**HIGH TECH CORRIDOR DEVELOPMENT, LLC
HARRISON COUNTY, WEST VIRGINIA**

WHITE OAKS PASE II A

ADDENDUM #2

THRASHER PROJECT #T30-11114

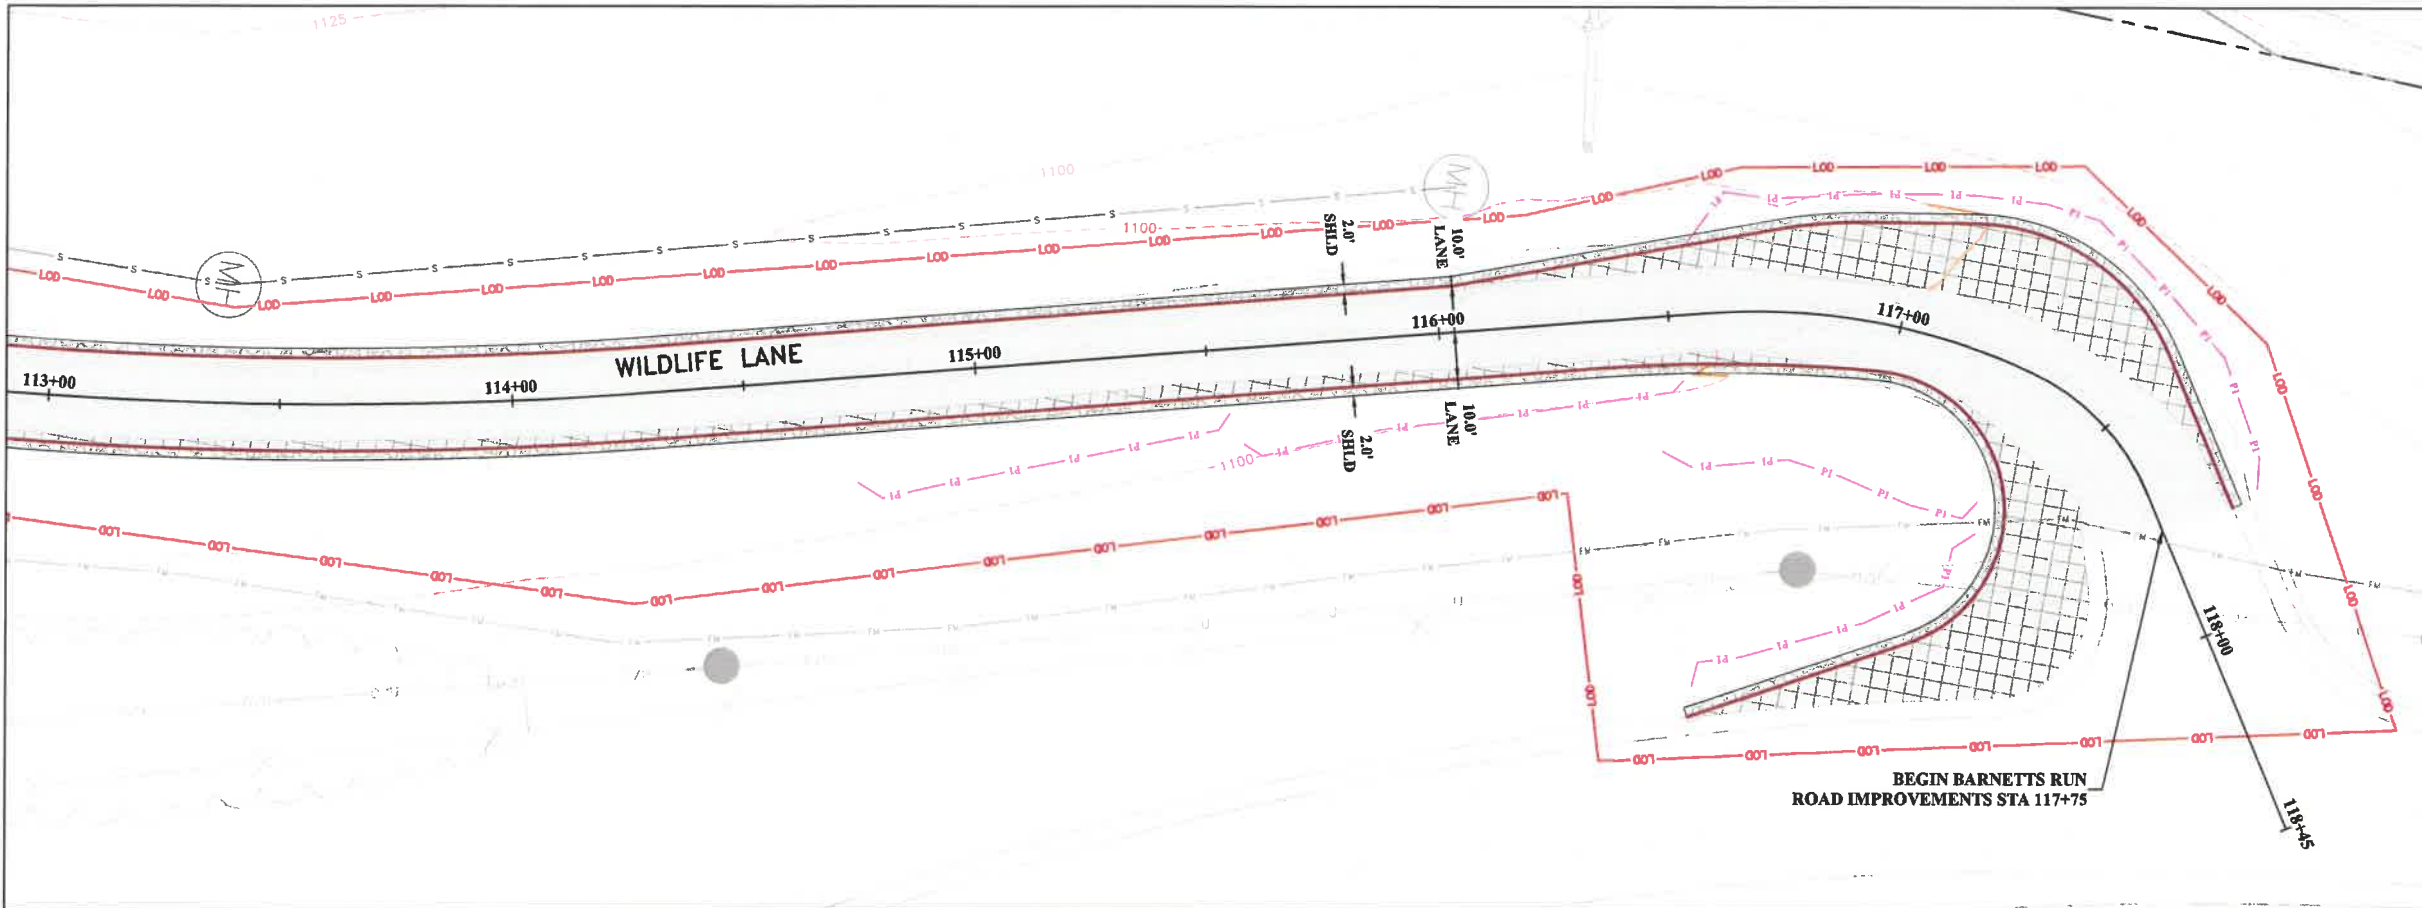
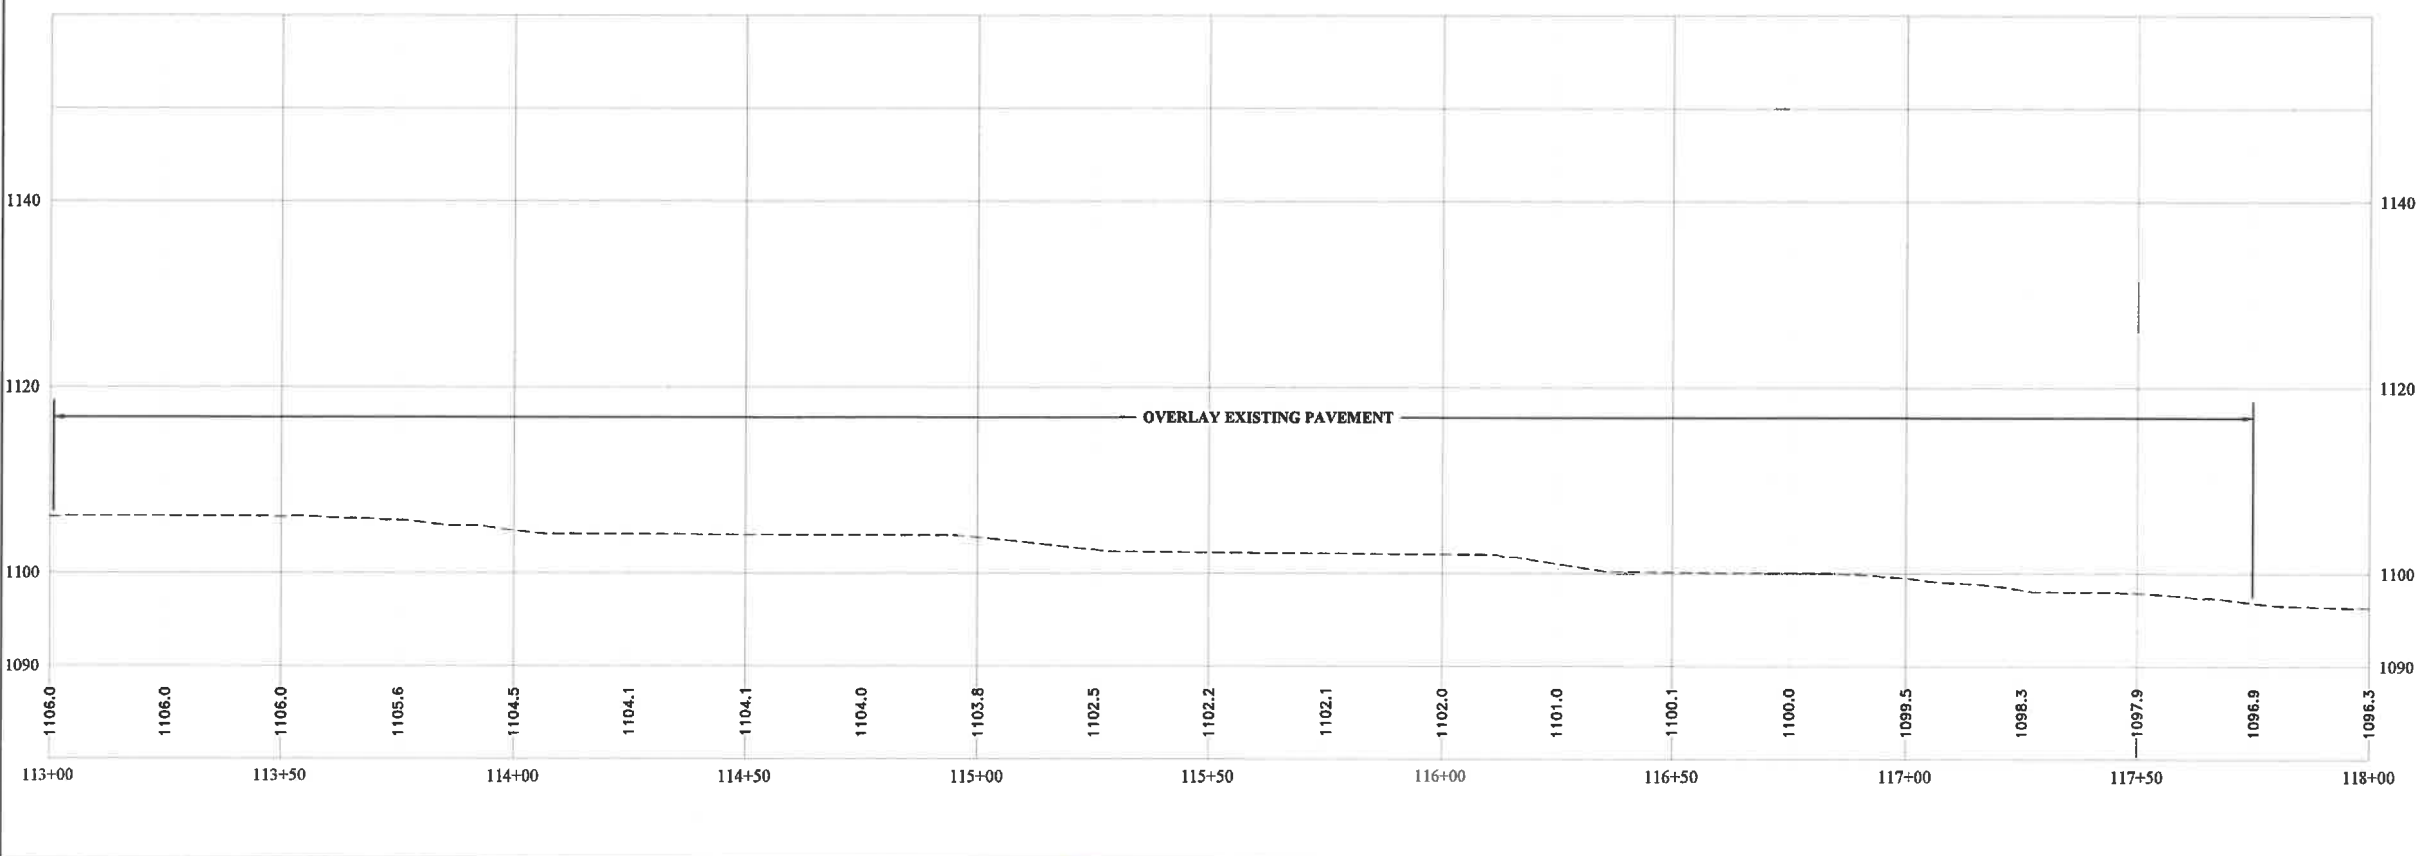
Plan sheet 31- Is the pipe shown under the Pad 2 Access Road entrance from Wildlife Lane the 18" diameter HDPE?

Yes
